City of Surrey PLANNING & DEVELOPMENT REPORT File: 7918-0401-00

Planning Report Date: December 2, 2019

PROPOSAL:

to permit the development of a 6-storey apartment building consisting of 127 dwelling units.

SHEET TITLE SOFT LANDSCAPE PLAN LEVEL 4 & ROOF

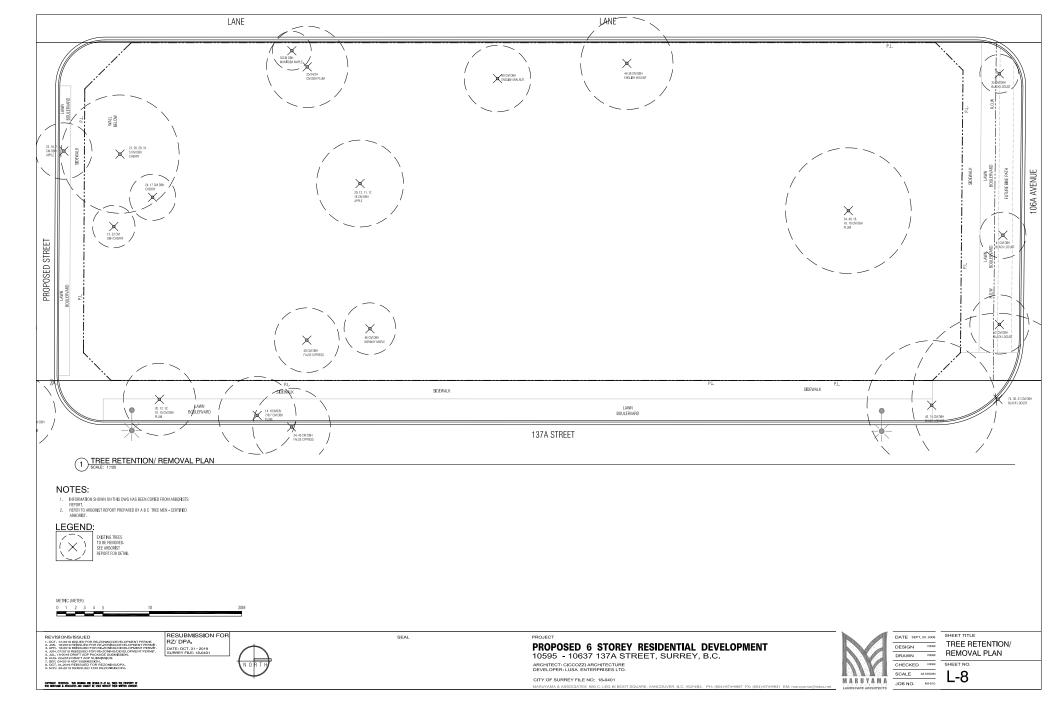
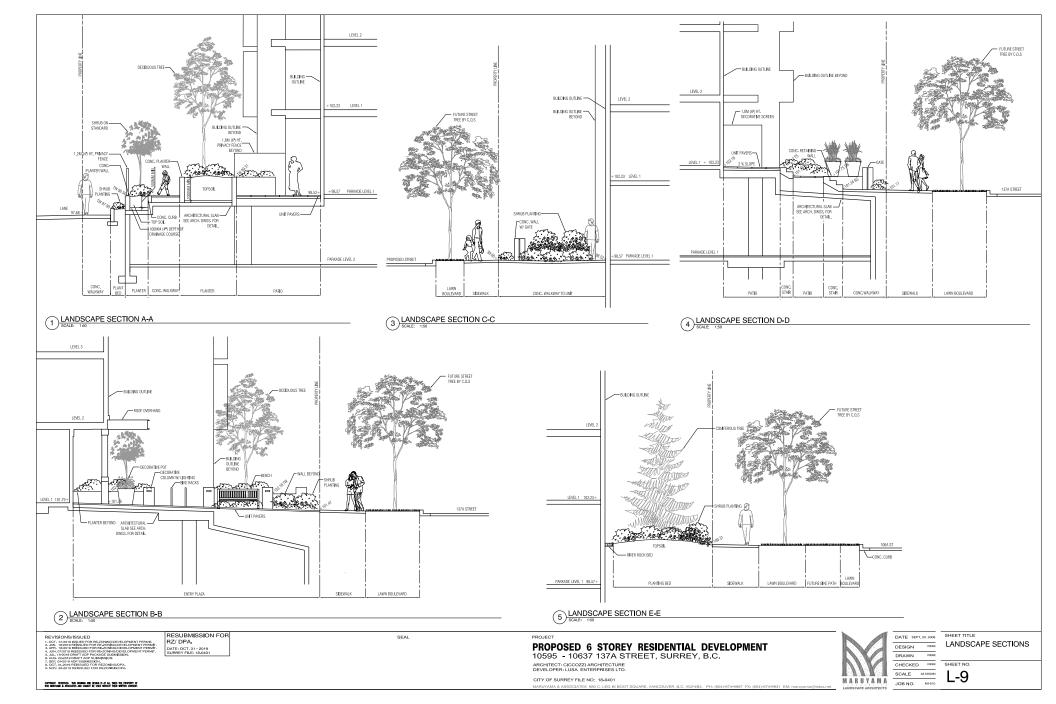
- Expand programming on amenity rooftops. Roof top amenity space expanded and revised to consolidate common uses and will allow multiple uses. BBQ station (uncovered) and additional patio tables added.

Consider different uses to the programming on the amenity rooftops.
 Roof top amenity space has been enlarged and revised to consolidate common uses. Additional space will provide multiple use activities.
 BBQ station and additional patio tables added.
